Staff Report Memorandum

Subject: Woodhaven Estates -

Preliminary Subdivision and Site Plan Review

SUB01182023-006471 SPR01102023-006464 SPX110820023-006652 PUD (12) 2.03 Acres

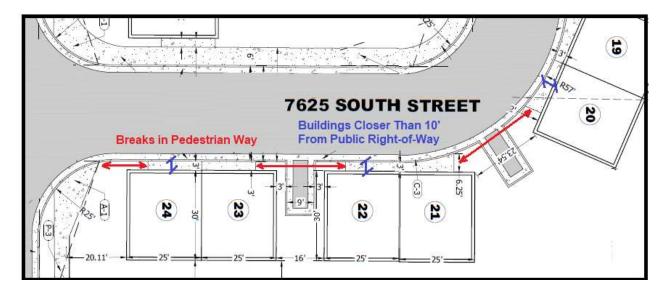
The applicant is proposing the elimination of sidewalks on one side of the street and parkstrips on both sides. The proposal is for the creation of a 38 foot public street which includes a 6 foot adjacent sidewalk, 2-1/2 feet of curb and gutter on either side, and 27 feet of asphalt.

Road Design and Pedestrian Paths. The applicant is seeking multiple exceptions and waivers for the proposed internal road design. The omission of sidewalks on one side and both parkstrips along the proposed street is not necessary to efficiently develop the property, nor does it further the objectives of the PUD. There are other design options available that would not require these omissions and would make the project more amenable to pedestrians. The applicant is seeking too many exceptions for road design which are in direct conflict with the purposes of the PUD Zone.

Preliminary Plat

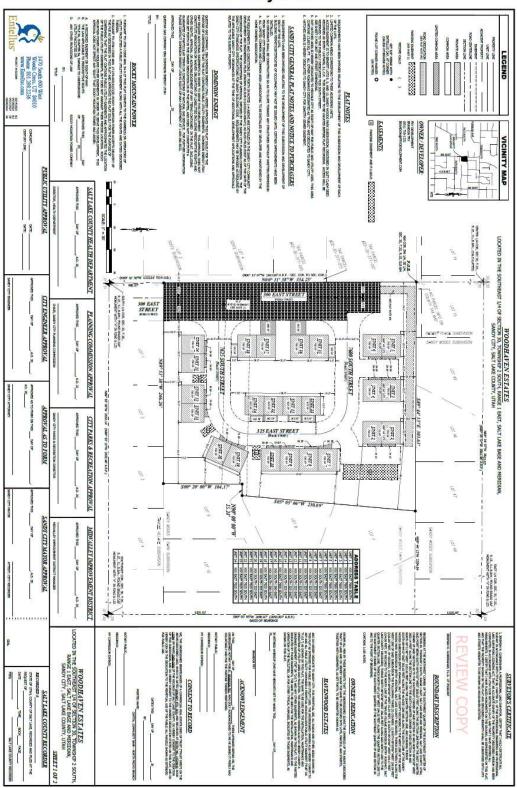
Unit Footprints. Staff is also concerned that the preliminary plat and site plan does not appear to include cantilevered portions of homes that must be included in the footprint of the private lots. As no dimensioned building plans have been provided, it is unclear how far these projections extend. Currently, the plan shows the face of several structures three feet from the street for many units. While staff supports the varied look of these buildings by having cantilevered elements, those do apply to building setbacks.

- 5. All structures and improvements for individual homes are to be restricted to the platted pad site, including but not limited to pop-outs, chimneys, porches, patios, decks, stairways, etc., and may not be built in the common areas.

- 6. That the setbacks for the subdivision be determined by the Planning Commission and that these setbacks be recorded as a note on the plat.
- 7. That the existing structures on the lots be demolished prior to recording of the subdivision plat.

Site Plan

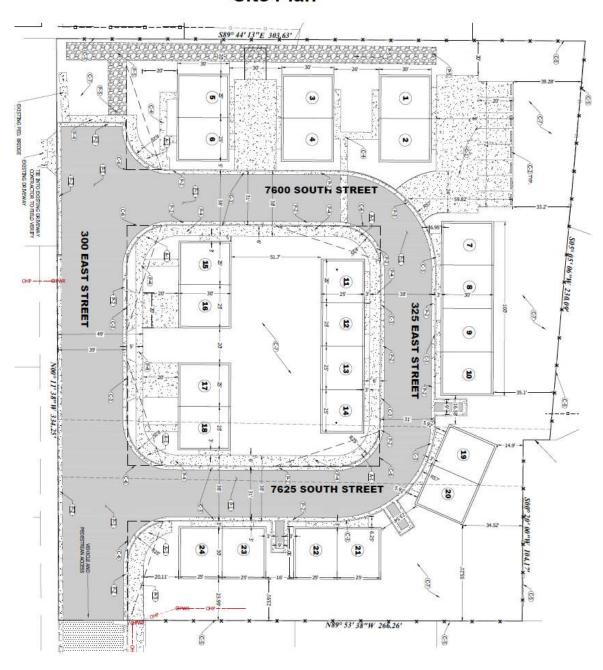
The proposed development is for 24 residential units consisting of duplexes and fourplexes along a U-shaped public street. The units are placed in a manner that allows for an appropriate layout that respects the existing land uses. The applicant has setback the units to be similar to the surrounding zones, with similar massing and scale. Where dissimilar uses are proposed, an increased setback that doubles the minimum setback of the adjacent zone has been accomplished. The buildings are proposed to be set very close to the internal public street, being setback as close as three feet.

Setbacks. While the Planning Commission has broad authority to establish appropriate setbacks (especially those internal to the development), there are certain standards that the code requires. Buildings within a PUD are required to be at least 10 feet from a public street. This space is to be reserved for street trees and landscaping features. Many of the residential structures proposed do not meet this requirement, with front doors 3 feet from the public right-of-way.

- 3. That all city provisions, codes, and ordinances are adhered to during the review, construction, and operations process of this project.
- 4. All pad site areas be revised to accurately reflect all cantilevers, chimneys, porches, patios, decks, etc.

- 6. That the applicant works with staff to amend the layout and configuration of the development to better align and comply with the purpose, design objectives, and setback requirements of the Planned Unit Development code. If there is a significant change in layout and configuration of the development that it be required to come back to the Planning Commission for approval.
